Consultation with the Lead Local Flood Authority on the Proposed Development at Land South-East of Rugby Road, Clifton-upon-Dunsmore

Thank you for your comments regarding the outline planning application for a proposed residential development and associated works at Land South-East of Rugby Road, Clifton-upon-Dunsmore (planning application reference: R25/0565; consultation reference: WCC003605/FRM/SL/001).

Richborough
Land East of Rugby Road
Clifton-upon-Dunsmore, Rugby
Culvert Capacity Assessment Technical Note

Drawing Title
SuDS design cross sections Sheet 1

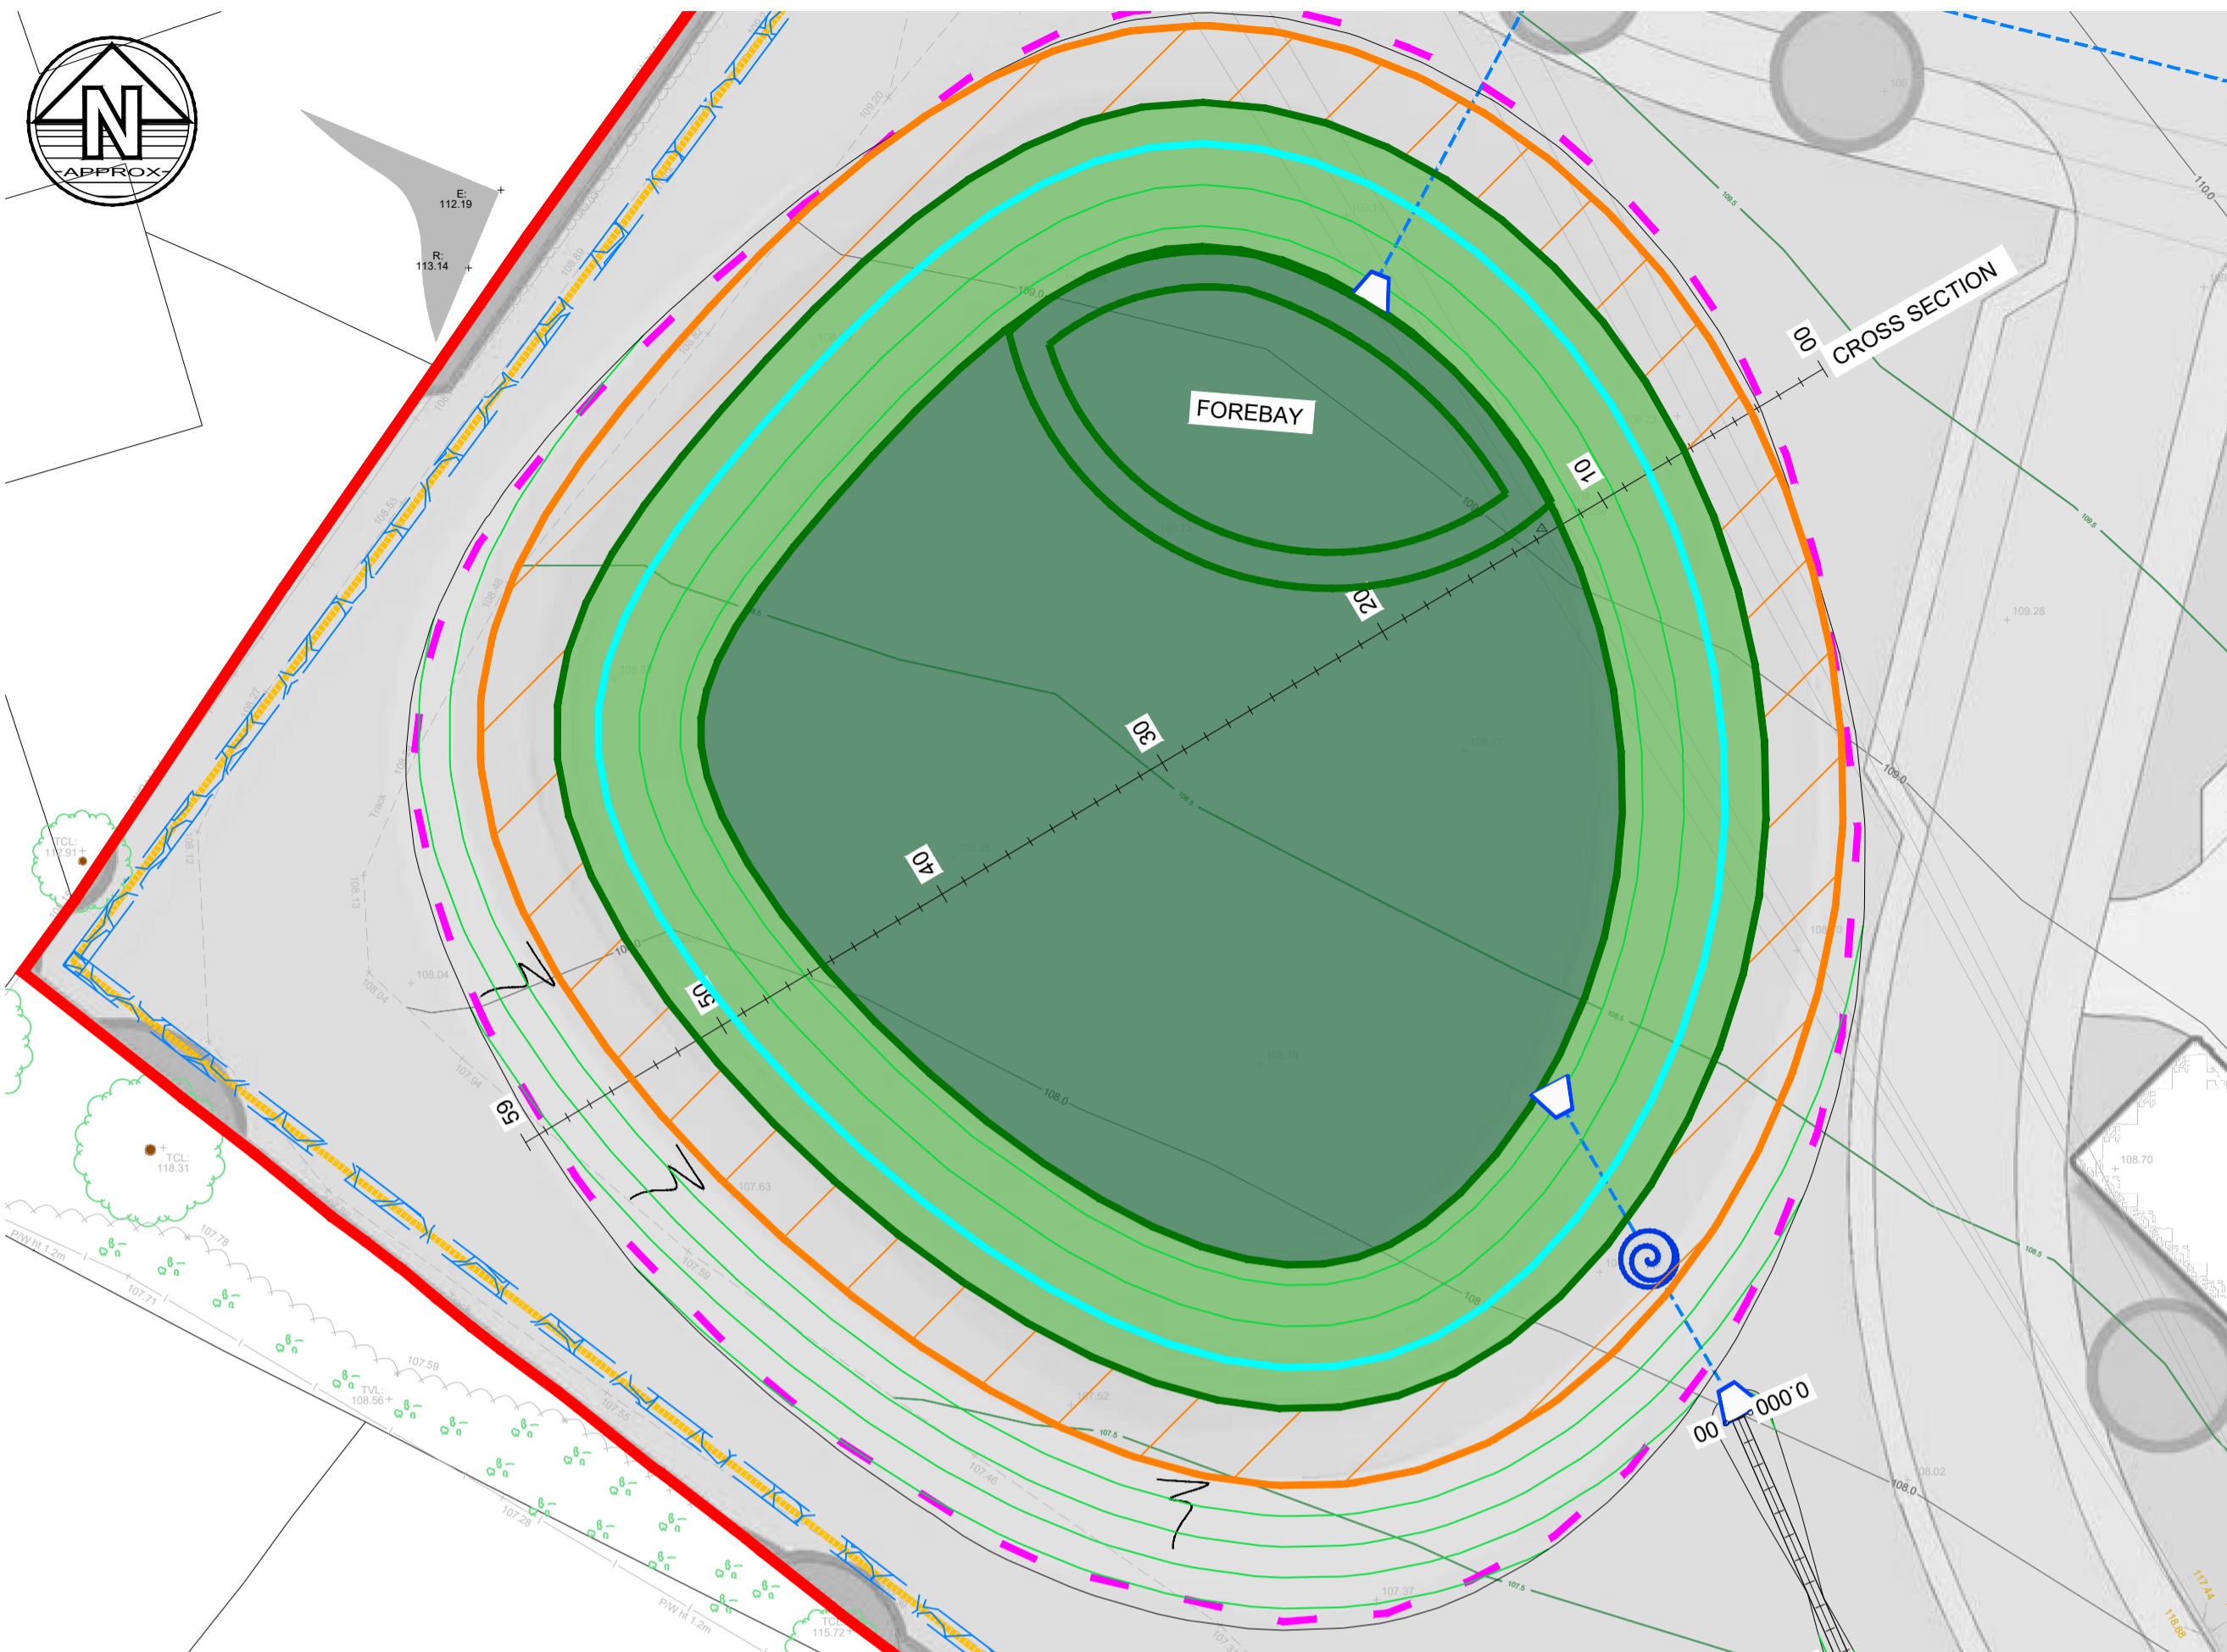
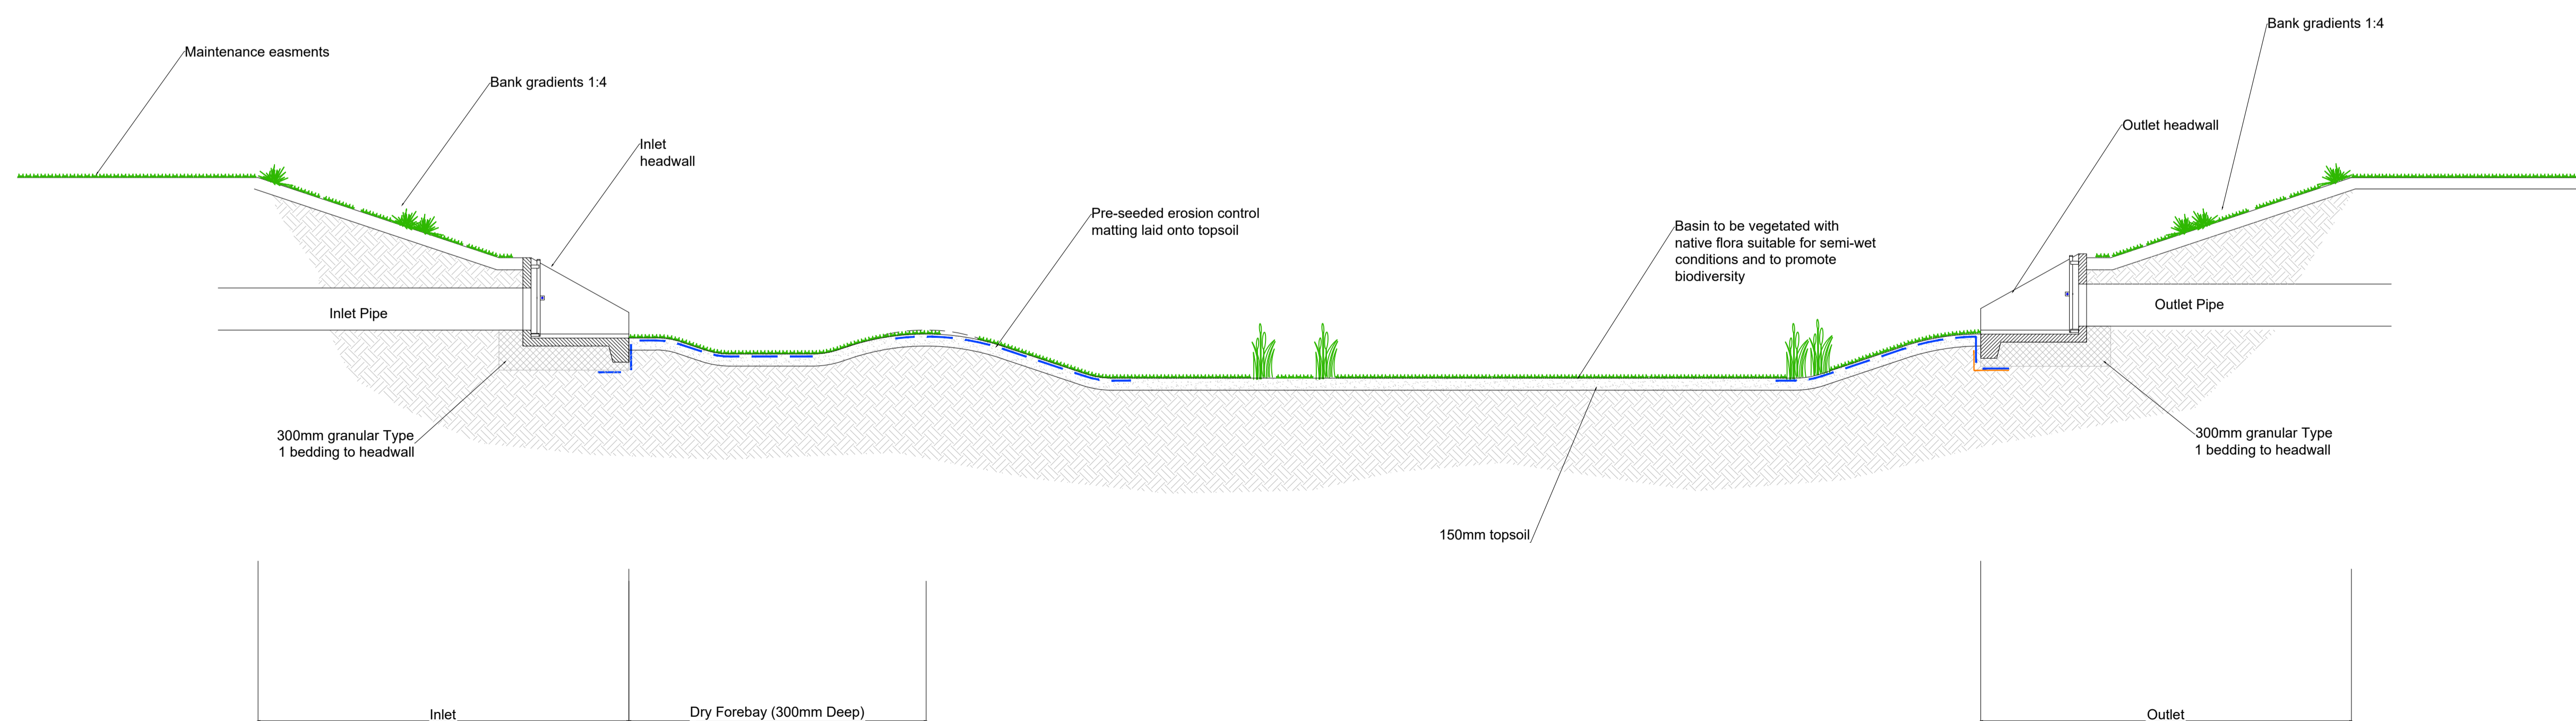
Following the additional survey, the surface water drainage strategy has been reviewed which has confirmed that a gravity-led outfall will be feasible. As part of this review, indicative cross-sections of the attenuation features have also been produced as suggested in the LLFA's comment and can be seen in **Appendix 2** (reference: 244849-BWB-ZZ-XX-D-W-0002). This has shown that it is suitable to locate the attenuation basins in the proposed locations within the site.
